***Subject: Nestlé Waters North America Inc. ("NWNA") Application for Permit Revision to 1041 Permit ("Permit") and Special Land Use Permit ("SLUP") Regarding Surface-Water and Groundwater Monitoring and Reporting Reduction***

## **Proposed Surface Water and Groundwater Monitoring and Mitigation Plan Ruby Mountain Springs and Bighorn Springs Sites Chaffee County, Colorado**

**December 1, 2014**

Figure 2  
 Ruby Mountain Springs  
 Upper Hagen Flume Flow and Groundwater Elevation Change

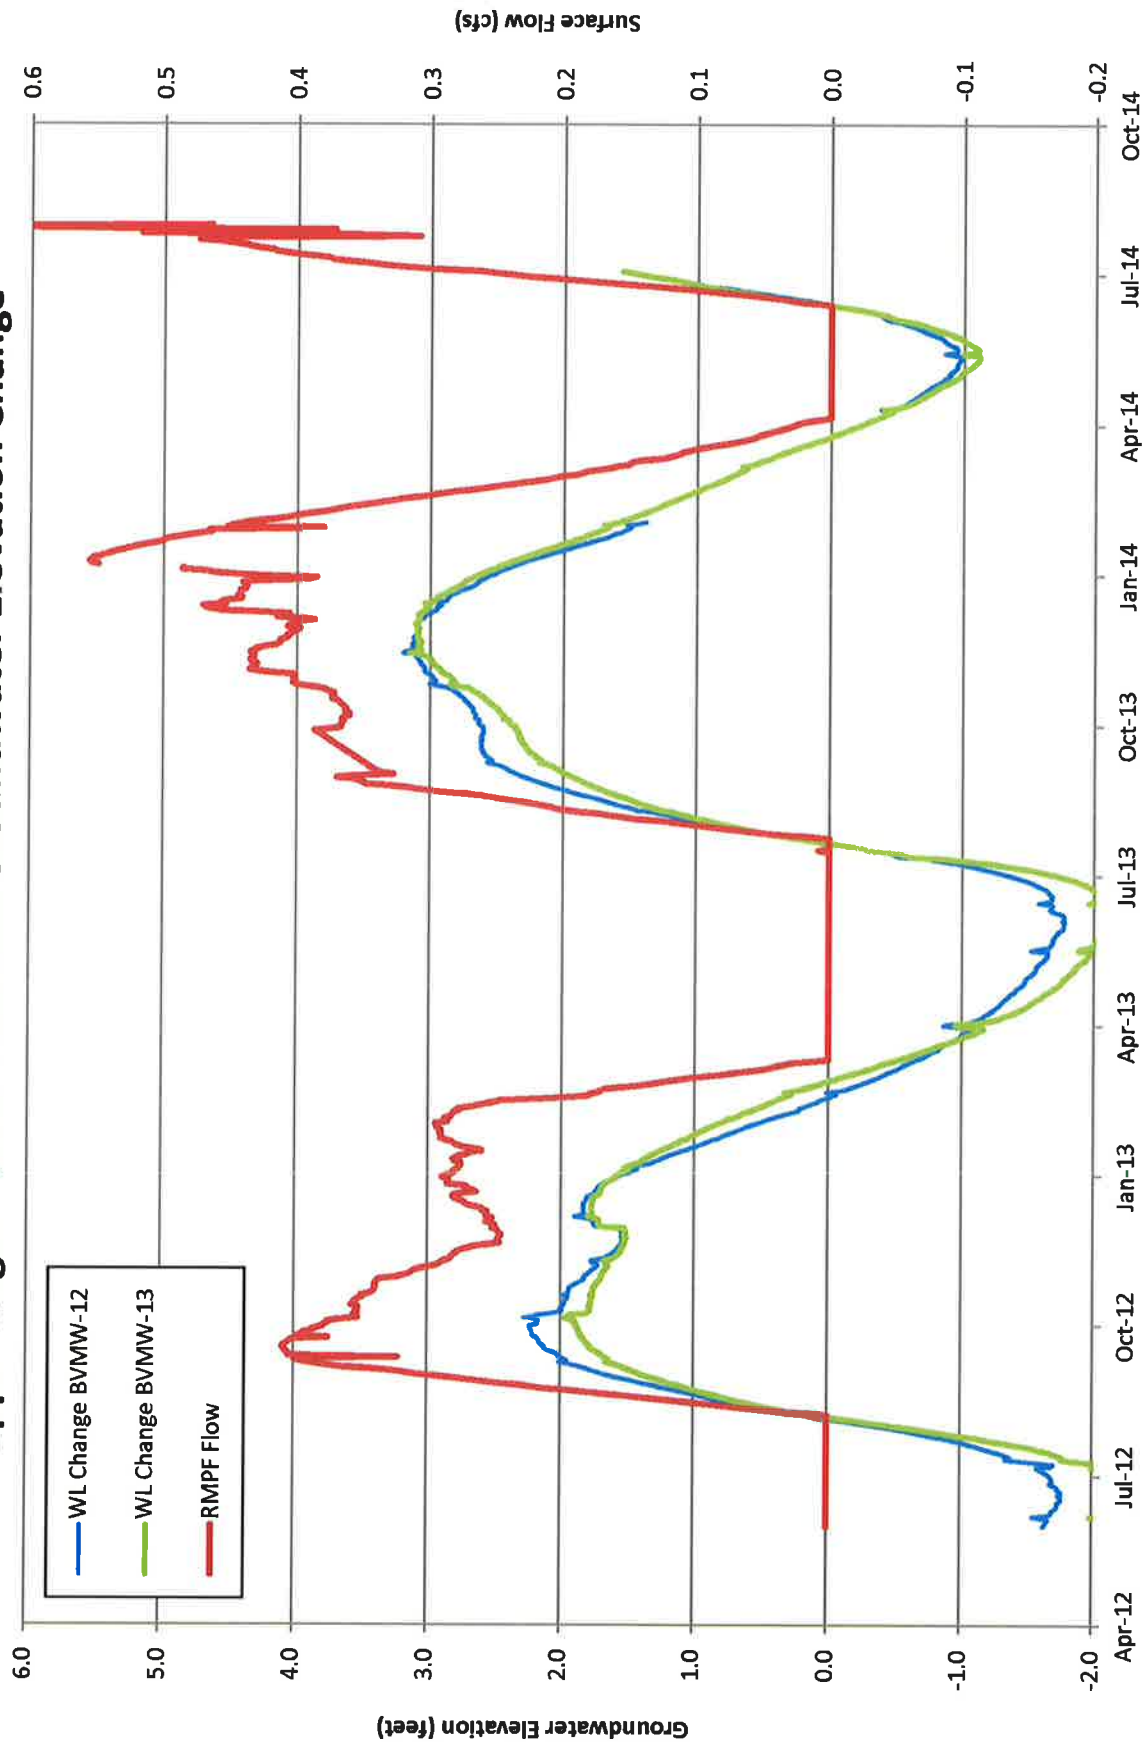
NWNA has done a correlation analysis for Upper Flume flows in relation to water-level measurements from the shallow monitoring wells BVMW-12 and BVMW-13 similar to that performed for the RMS weir. Figure 2 in Exhibit 4 shows the relation of flume flows to water-levels in the two monitoring wells. Figure 3 in Exhibit 4 shows calculated flow rates as based on the water-levels in the monitoring wells. It can be seen that there is reasonable agreement between calculated flow rates and actual flume measurement for most of the period measured with the following observations: (1) there is a lag of 4 to 6 days in well water levels relative to flume flows likely due to the spring sources in the upper ditch being up-gradient relative to the monitoring wells, (2) all water-levels below a certain threshold correspond to the no-flow condition of the flume, and (3) reduced (and erratic) flume flows during the winter season 2013-2014.

NWNA submits that the flume flows predicted by water-levels in BVMW-12 are sufficiently representative of measured flume flows relative to the magnitude of normal fluctuations in flows from season to season and from year to year that measurements of flows from the flume are unnecessary.

Therefore, NWNA requests that the County approve the cessation of monitoring and reporting from the RMS Upper Flume and replace those measurements with calculated flows through the upper ditch based on water-level measurements from BVMW-12. NWNA intends to monitor and report these calculated flows for as long as NWNA operates its Ruby Mountain Springs project and as long as the upper ditch is maintained and allowed to operate by its owner. Upon abandonment of the upper ditch by its owner, NWNA will cease reporting calculated flows for the Upper Flume.

**Figure 2**  
**Bighorn Springs**  
**Flume Flow and Groundwater Elevation Change**

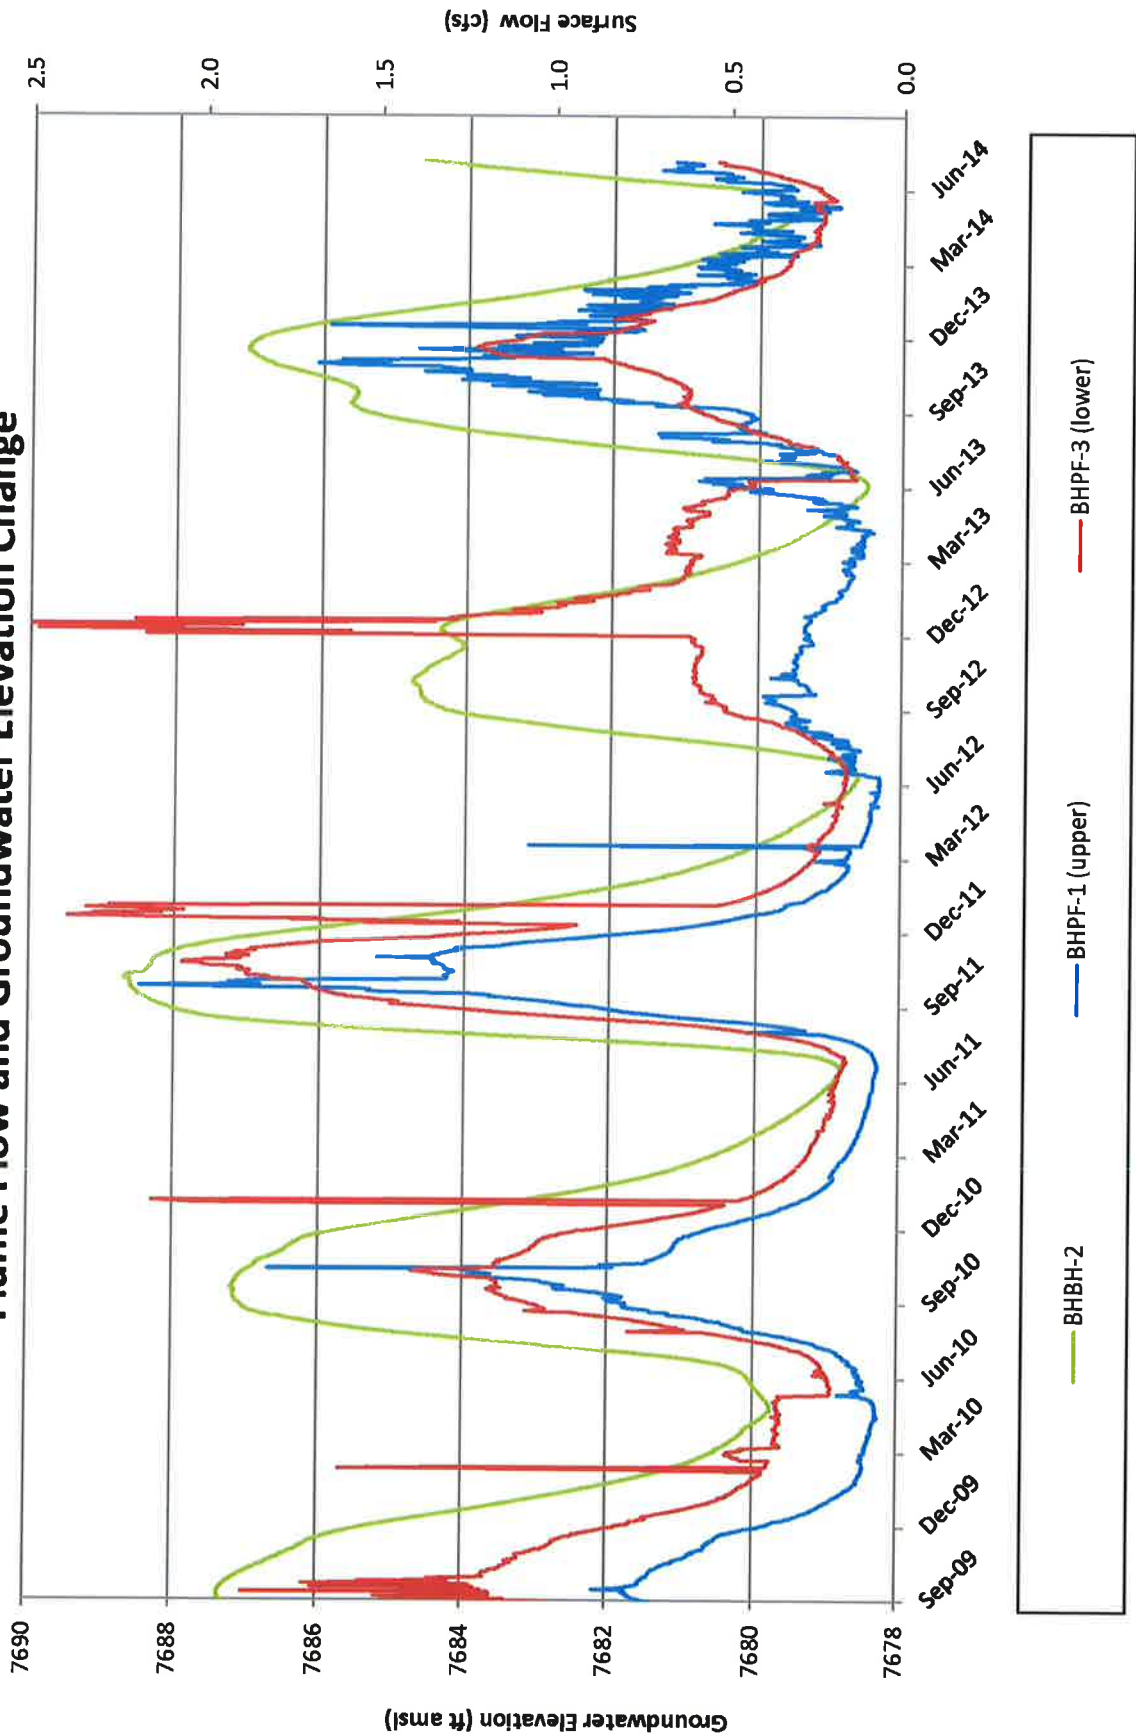
NWNA has performed a correlation analysis for the BHS flume flows in relation to water-level measurements from the monitoring wells BHBH-2 similar to that performed for the RMS weir. Figure 2 in Exhibit 5 shows the relation of flume flows to water-levels in the monitoring well. Figure 3 in Exhibit 5 shows calculated flow rates as based on the water-levels in the monitoring well. It can be seen that there is reasonable agreement between calculated flow rates and actual flume measurements when obviously erratic data are omitted for the period measured. In fact, for the period June 2013 to June 2014, the calculated flows for these flumes actually shows the correct relationship between the two flumes in that the lower flumes shows higher flows than the upper flume.

Therefore, NWNA requests that the County approve the cessation of monitoring and reporting from the BHS Parshall flumes BHPF-1 and BHPF-3 and replace those measurements with calculated flows based on water-level measurements from BHBH-2.
